BWR OWNERS' GROUP

BWROG-06024
August 29, 2006

SUBJECT: Responses to Requests for Additional Information (RAIs) Dated May 3, 2006, Regarding the BWROG Topical Report SIR-05-044, "Pressure Temperature Limits Report Methodology For Boiling Water Reactors," Revision 0 (TAC NO. MC9694)

**BWROG Response to NRC Request For Additional Information
Boiling Water Reactor (BWR) Owners' Group
Topical Report (TR) SIR-05-044, "Pressure Temperature Limits Report
Methodology For Boiling Water Reactors," Revision 0**

Figure 2-7: Nozzle Thickness Definition

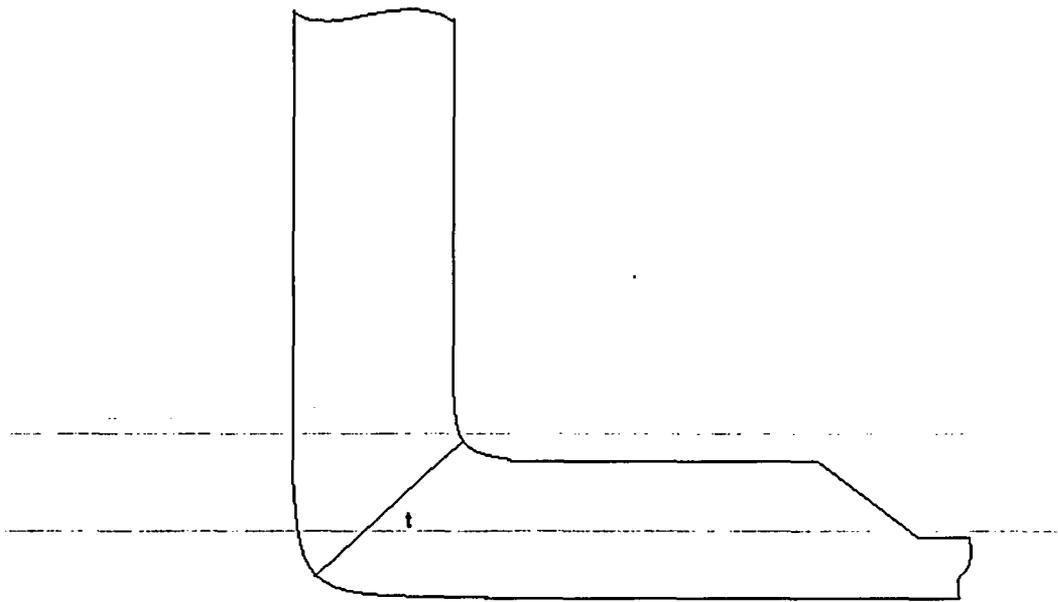
3. Section 2.5.3, "Thermal and Pressure Stress Intensity Factor Calculations for Discontinuity Regions," indicates that the thermal stress intensity factor, K_{It} , for P-T limits for nozzles is dependent upon the membrane correction factor for an inside surface axial flaw and the thickness (t). The thickness term is not defined. Define the thickness to be used in determining the membrane correction factor for the K_{It} analysis for nozzles.

Starting on page 2-20 of the TR, replace the entire "Non-Beltline Region" section with the following. This replacement text is considered to provide further detail and clarification that responds to the RAI [quotation below concludes on page 8]:

For a path through the limiting nozzle inner blend radius corner, as shown in Figure 2-7, the thermal and pressure hoop stress distributions should be extracted from the finite element model. Each of the stress distributions should be fit with a third-order polynomial that reasonably fits the calculated stresses in the region of interest.

t = thickness of the cross-section through the limiting nozzle inner blend radius corner, as shown in Figure 2-7.
 $C_{0t}, C_{1t}, C_{2t}, C_{3t}$ = thermal stress polynomial coefficients based on fits to finite element analysis.

The figures below will be added as new Figures 2-7 and 2-8 of the TR.
